Device Name or Description: DØ SOLENOID MAGNET LIFTING FIXTURE

SUBJECT: Review and Recommendations Concerning the  
D-Zero Solenoid Lifting Fixture #102

STRESS ANALYSIS OF THE D-ZERO SOLENOID  
MAGNET LIFTING FIXTURE  
PPD FIXTURE # 102

D-ZERO ENGINEERING NOTE # 3823.111-EN-472

Figure 4: Top Beam with Bolt Hole Detail

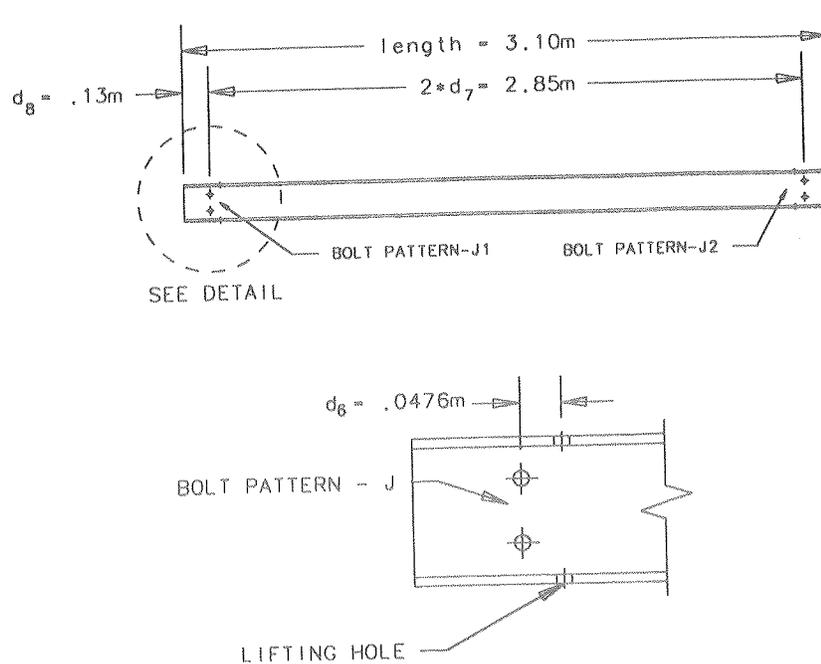
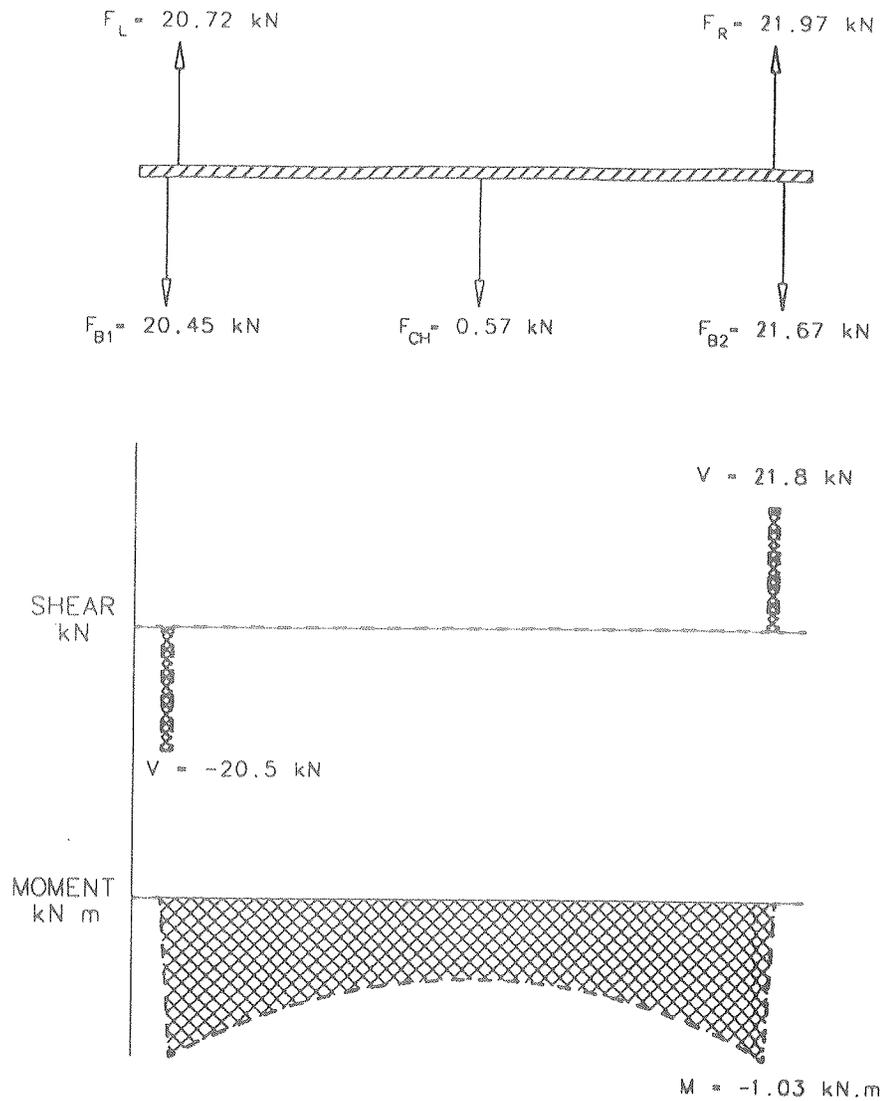
Prying action should be looked at for bolt patterns J, F, and G. See AISC ninth Edition ASD, page 4-90.

You are correct. Prying action on bolt pattern J (Top beam bolted connection) may not be negligible. The required flange thickness (from ASD page 4-90) to neglect prying is 1/2". My solution to this issue is to shorten the top beam channel and then cap it with an end plate. The 1/4" or 3/8" thick end plate will be welded onto the end of the C-channel. The overall length of the C-channel will be shortened so that the end plate will be 3" past the center line of bolt pattern J.

SOLENOID LOAD TEST ARRANGEMENT

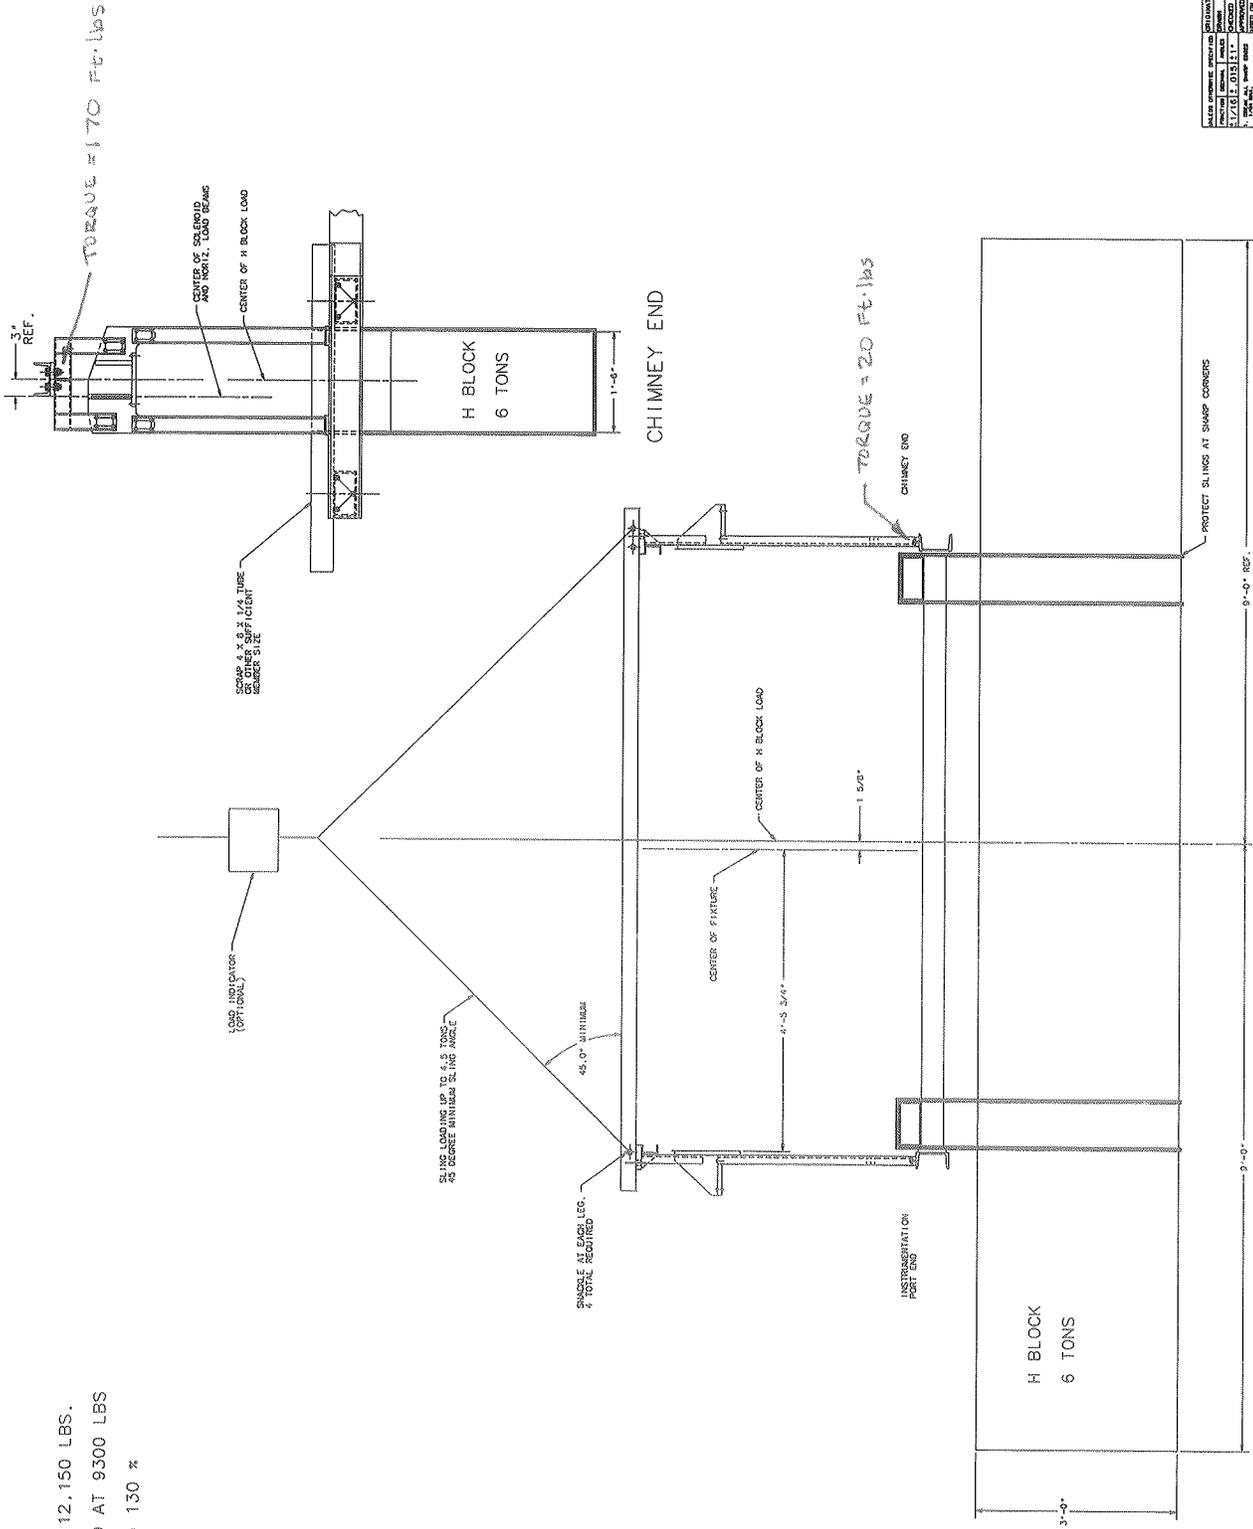
Will the load ever be lifted and moved from Pattern A and C without connected at Pattern B. If so then, then I would like to discuss stability. If Patterns A, B, and C are always used together then I have no other stability concerns.

Patterns A, B, and C will always be used together when moving the solenoid. During the load test only, patterns A, and C will be attached to a load (6 ton shielding block) which is hanging below the fixture. Pattern B will not be used on the load test.

I will send copies of the load test arrangement to your committee via lab mail. The drawings are 3823.111-ME-358413 (ass'y) and 3823.111-MB-358408 (load test beams taking place of solenoid). They can also be accessed electronically via "XDCS" in the d-zero mechanical vault. The load test won't happen any earlier than the first week in December.
